# **8600 WILSHIRE MIXED-USE PROJECT FINAL ENVIRONMENTAL IMPACT REPORT**

**Prepared for**  
**CITY OF BEVERLY HILLS**

## 8.0 COMMENTS AND RESPONSES

**PLANNING COMMISSION COMMENTS AT THE APRIL 27, 2006 PUBLIC HEARING**

FIGURE 8-1

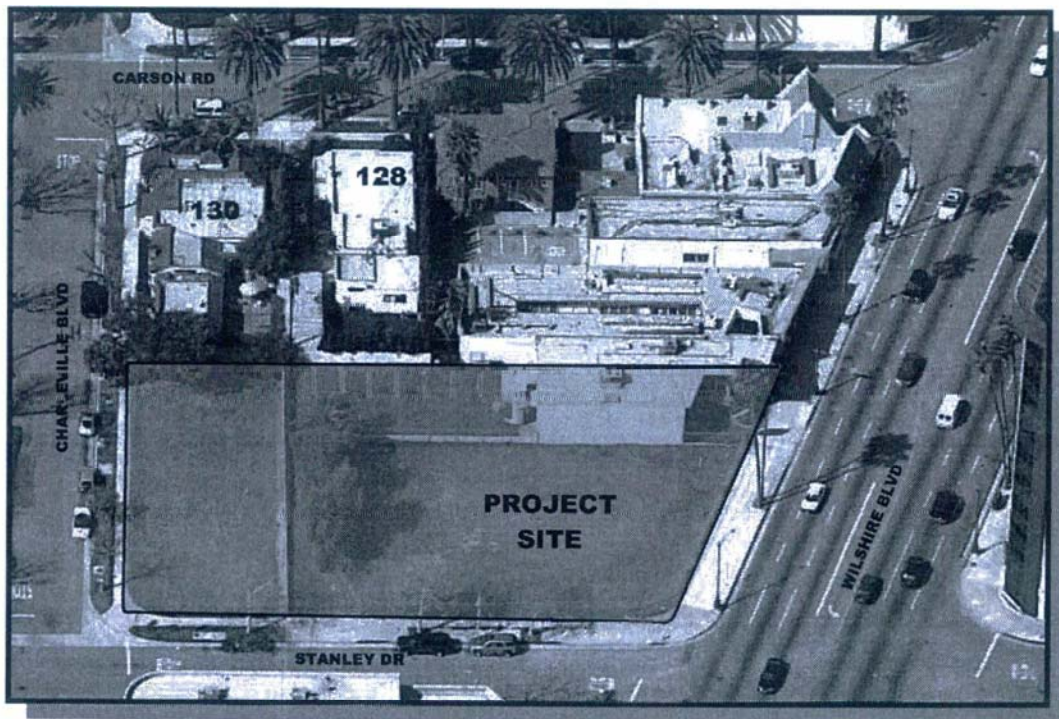
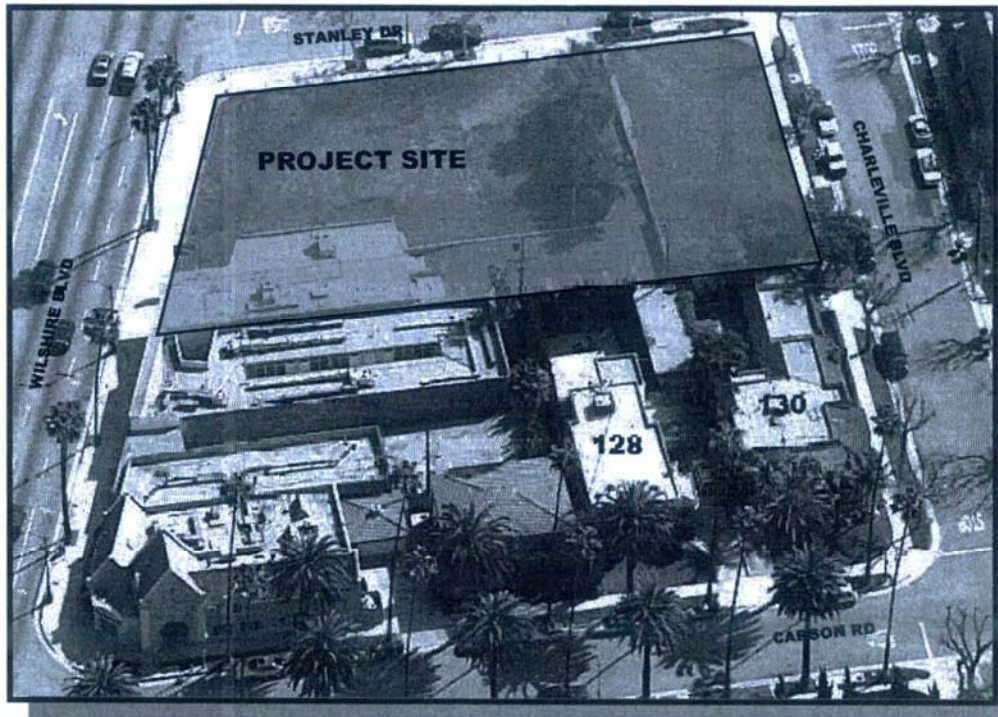
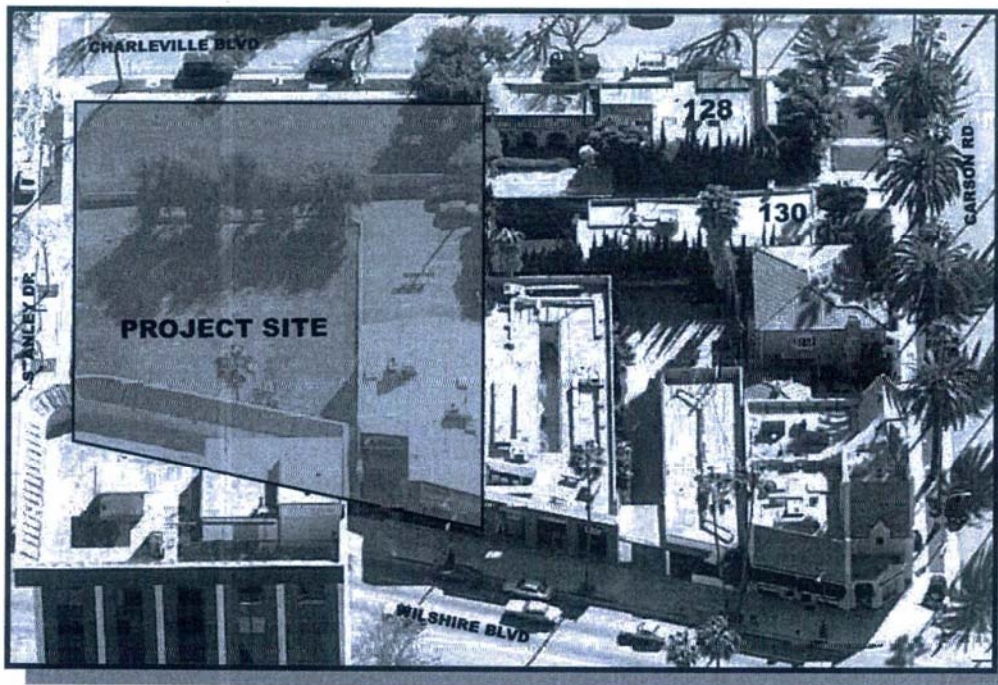
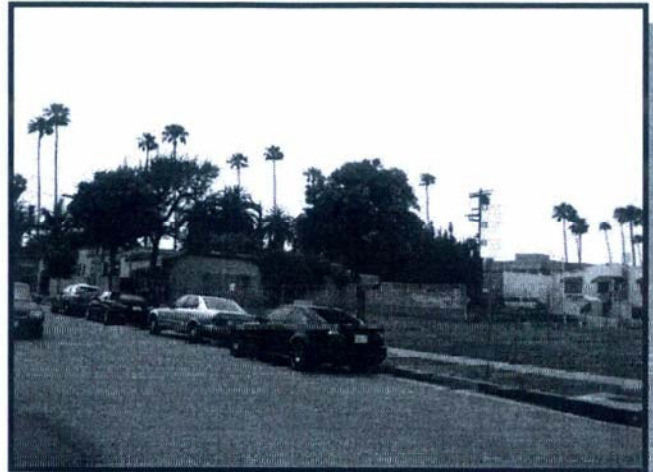
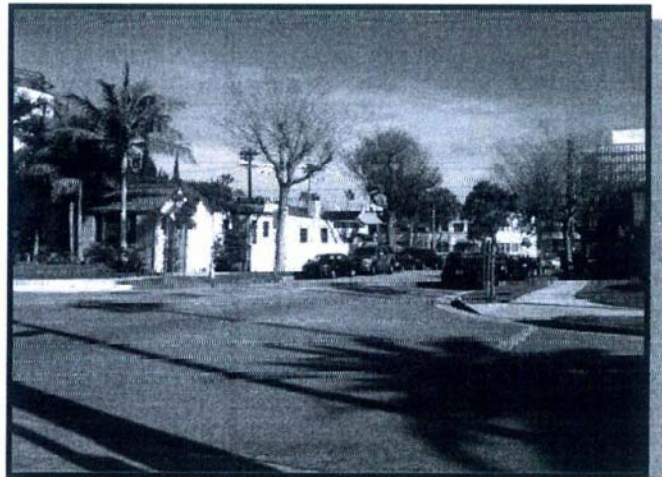
Section 4.1-2. Add photos on west side of Project.

**Figures 8-1 through 8-3**, which are included below, identify the residential uses to the west of the Project site on Carson Road.

FIGURE 8-4

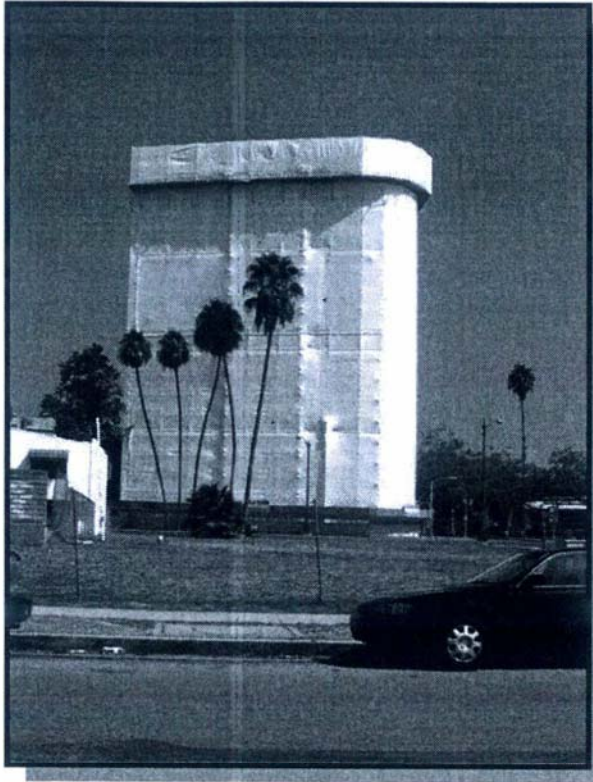
Figure 4.1-4: Caption reads “22-story 8601 Wilshire can be seen in the background.” This caption needs to be fixed.

The building at 8601 Wilshire is 11 stories rather than 22 stories. The caption to this figure has been revised. See **Figure 8-4**, below, for the revision.

FIGURE 8-5

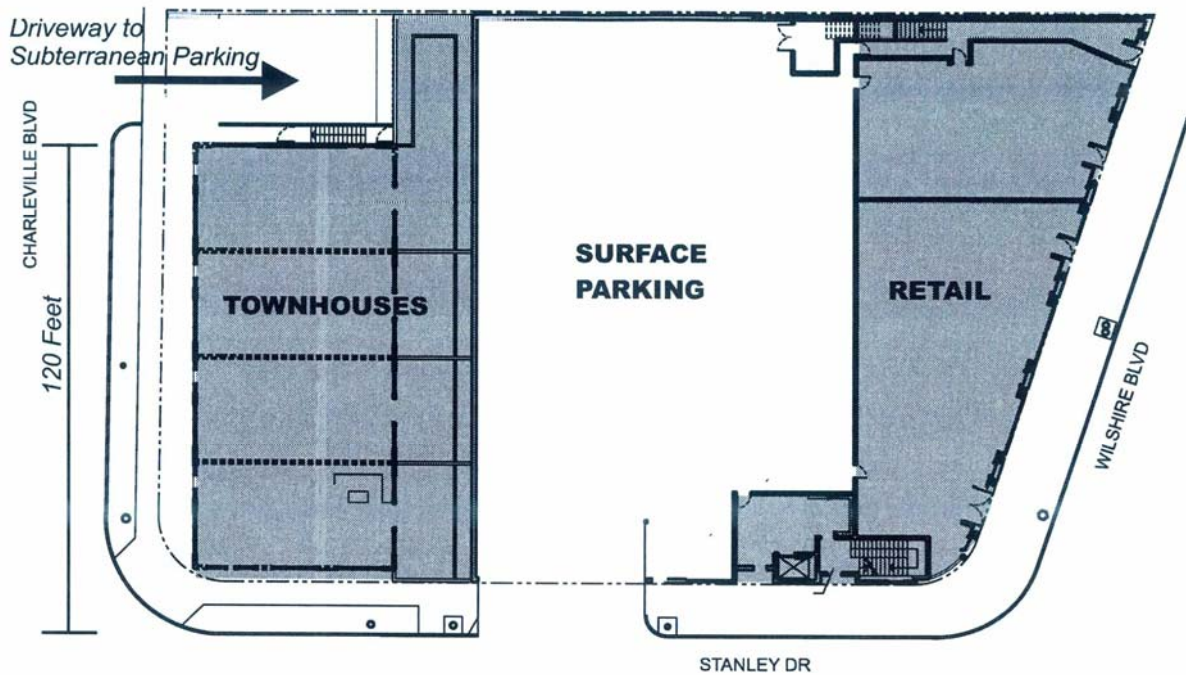
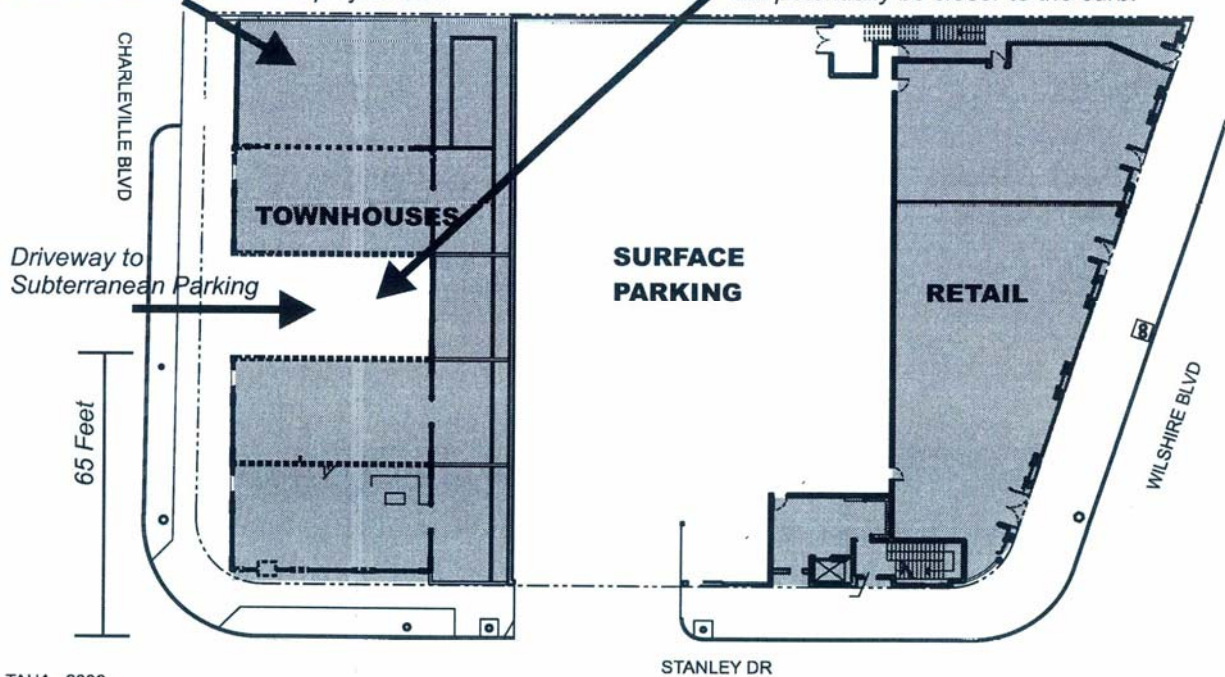
Provide alternative driveway locations to move the Charleville access further from the abutting single-family residences.

The proposed Project has two driveways that serve the proposed Project. One of the driveways is located on Stanley Drive, between Wilshire and Charleville Boulevards. This driveway provides access to the ground-level parking facility, which provides transient parking to commercial and residential guests. The second driveway is located at the southwestern corner of the Project site on Charleville Boulevard, adjacent to 130 Carson Road, a single-family residence. This driveway, which is approximately 120 feet west of Stanley Drive, provides access to the subterranean parking facility and is only accessible to residents of the Project site. The Planning Commission, as well as public comments, has expressed concerns regarding the location of the Charleville driveway. There are two alternative driveway locations that are available for the proposed Project. The two alternative driveway locations and its implications are discussed below.

**Relocated Charleville Driveway.** On Charleville Boulevard, the only feasible alternate driveway location to the subterranean parking facility would be between the four proposed townhouses. This driveway cannot be located further away from the adjoining single-family residence because the driveway would be located too close to the corner of Charleville Boulevard and Stanley Drive, which would create a traffic safety hazard. Under this scenario, the driveway would be located closer to the corner of Charleville Boulevard and Stanley Drive (approximately 65 feet, or three car lengths, west of Stanley Drive – see **Figure 8-5**, below). The proposed townhouses would be moved closer to the existing single-family residence and would overlook the backyards of the single-family residences to the west of the Project site. This alternative driveway location would not require major reconfiguration of the subterranean parking facility and would keep commercial and residential guest parking separate from residential parking.

FIGURE 8-16

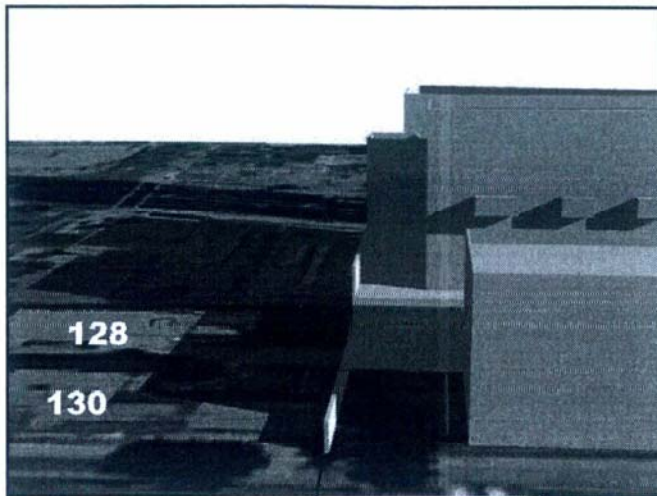
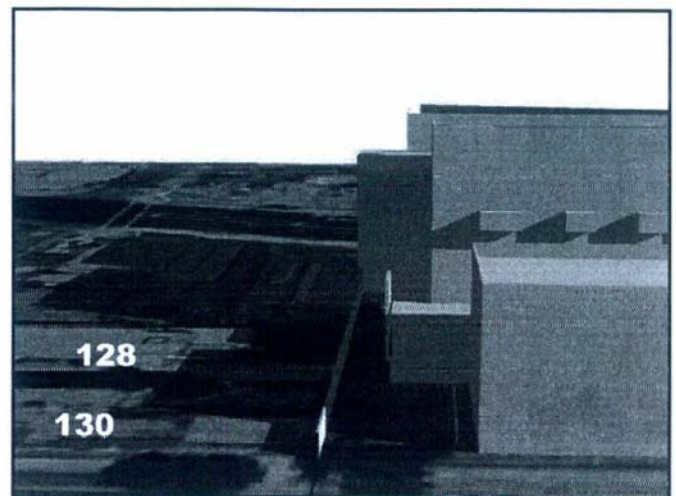
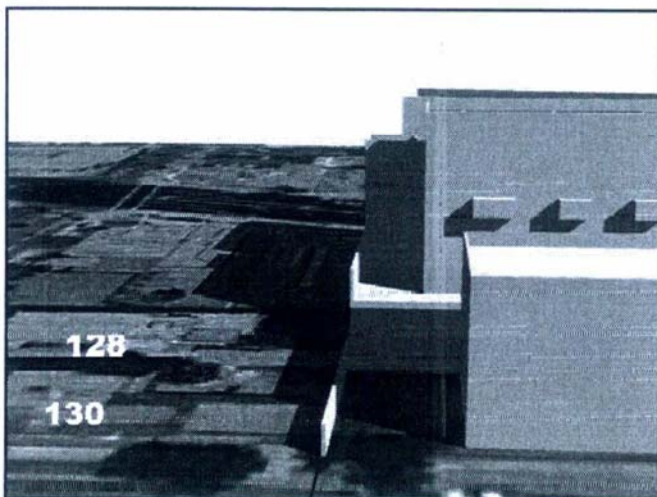
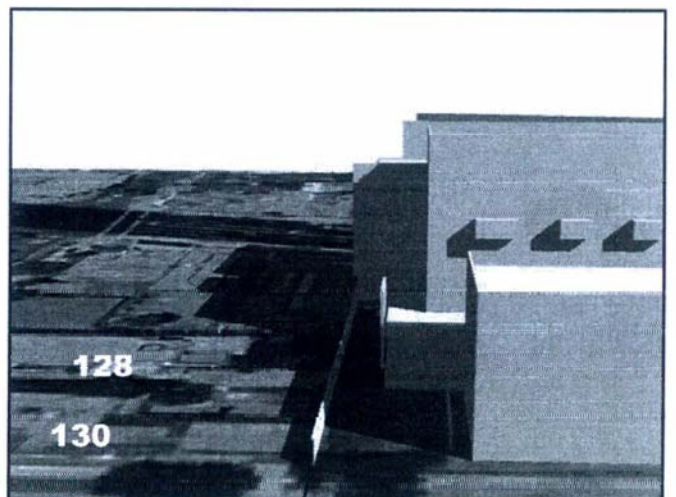
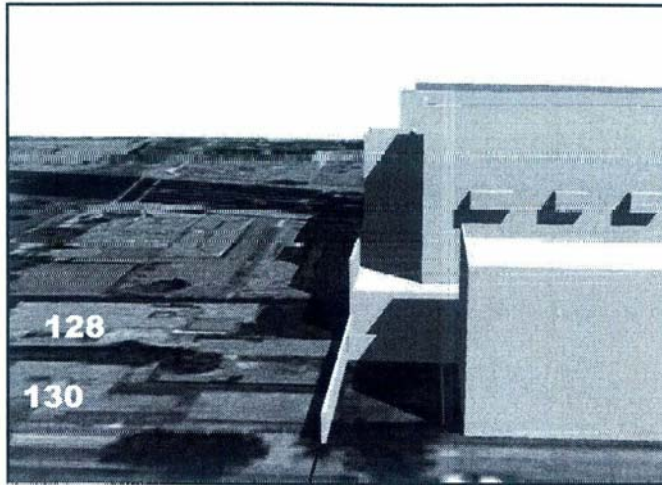
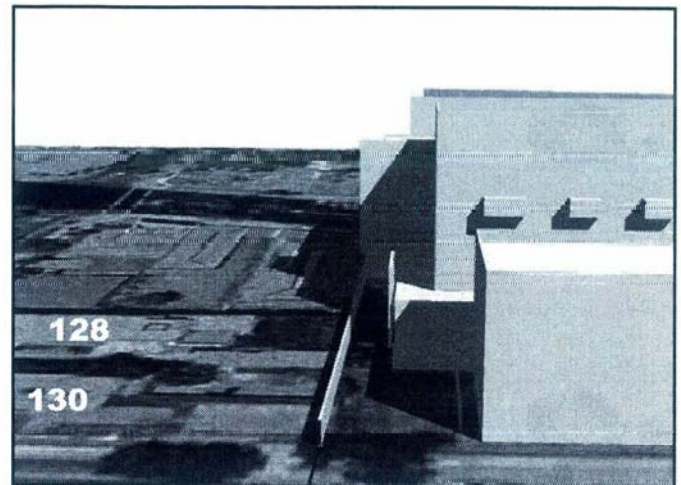
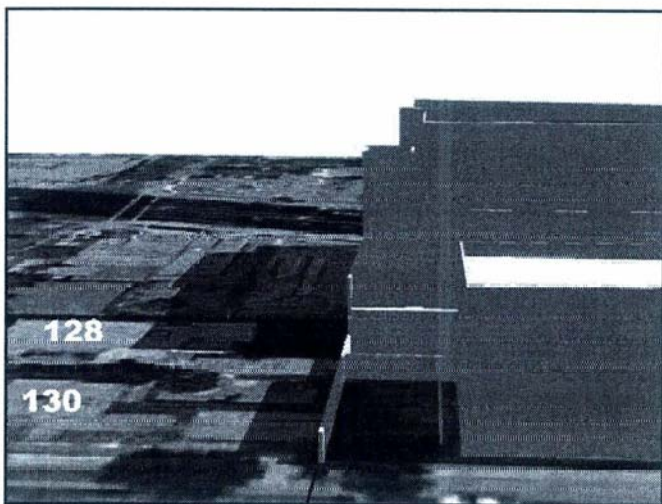
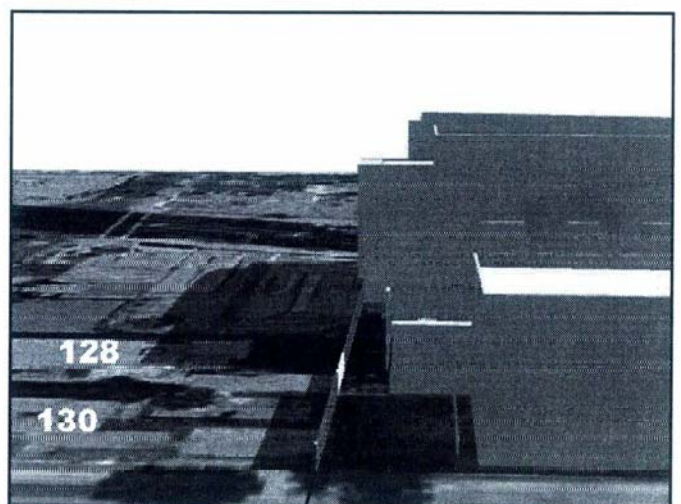
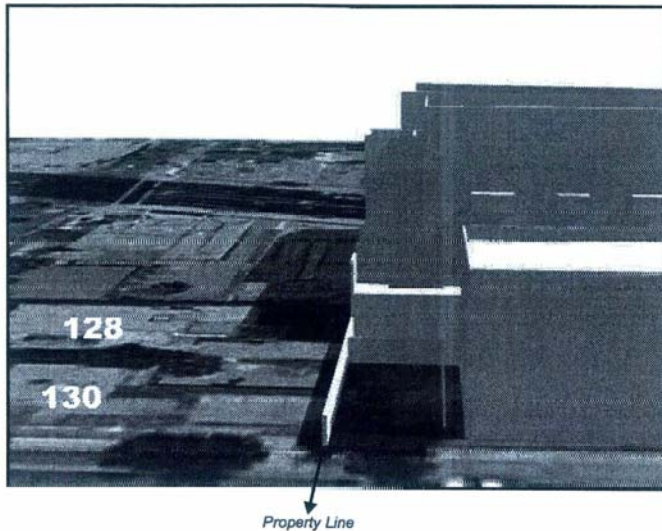
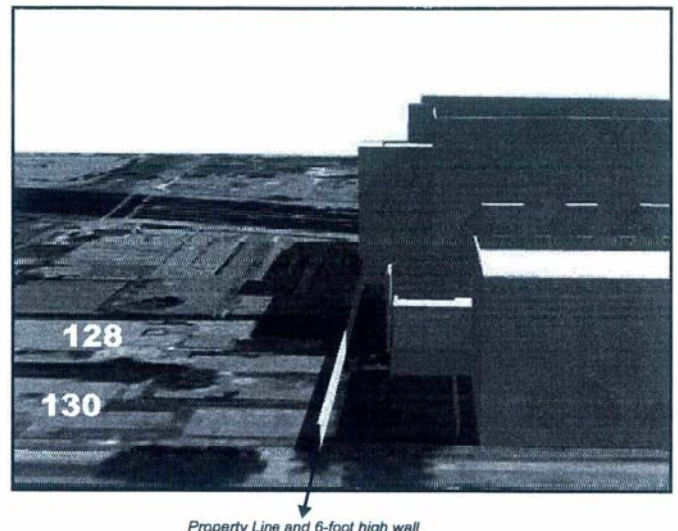
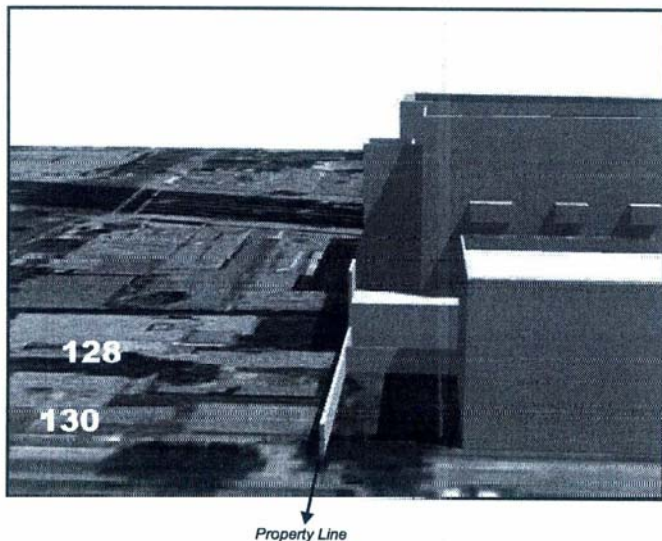
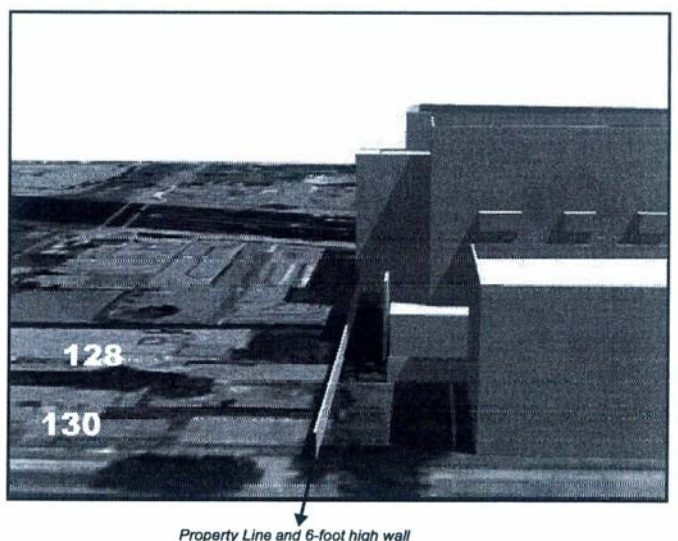
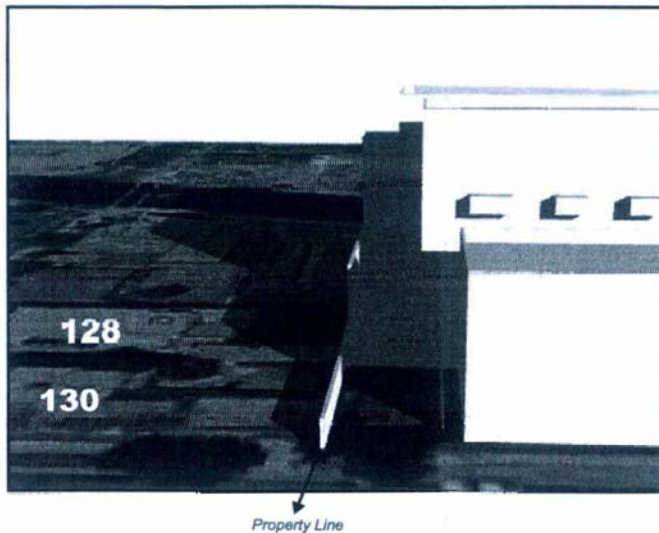
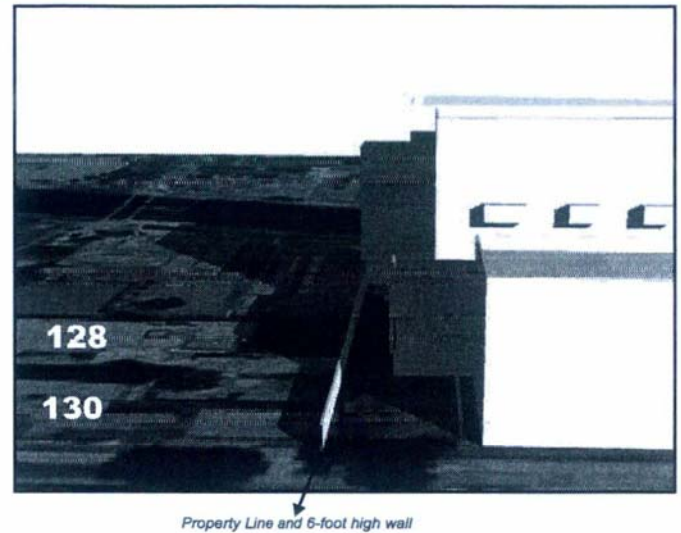
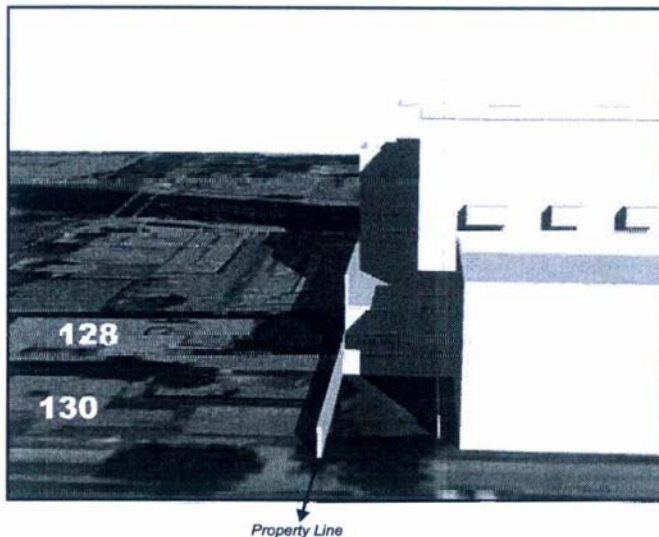
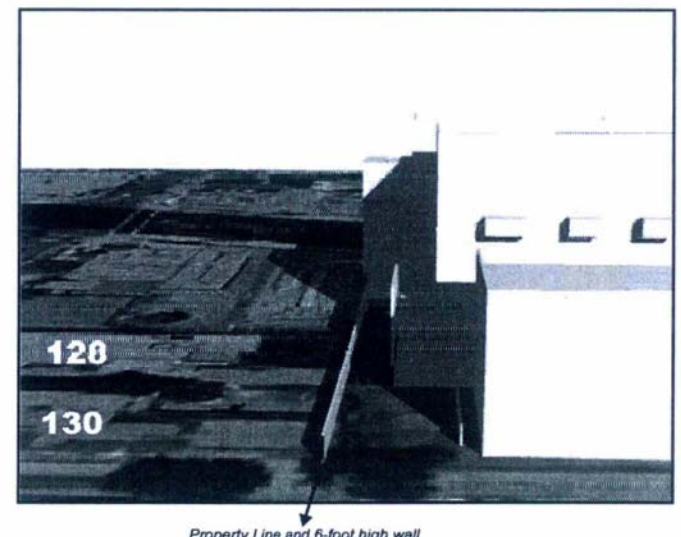
What would the mitigated shadow coverage levels be compared to the proposed Project (see Mitigation Measure A4 - setback the western perimeter of the wall at first floor of condo).

Mitigation Measure A4 recommends an increased setback for the proposed Project perimeter wall and ground floor. To be consistent with current code requirements, this setback is set at 10 feet from the property line. **Figures 8-15 through 8-18**, below, illustrate the incremental difference between the proposed Project shadow and the effectiveness of Mitigation Measure A4. As shown, shadow impacts would be reduced by approximately five to ten percent with implementation of Mitigation Measure A4.
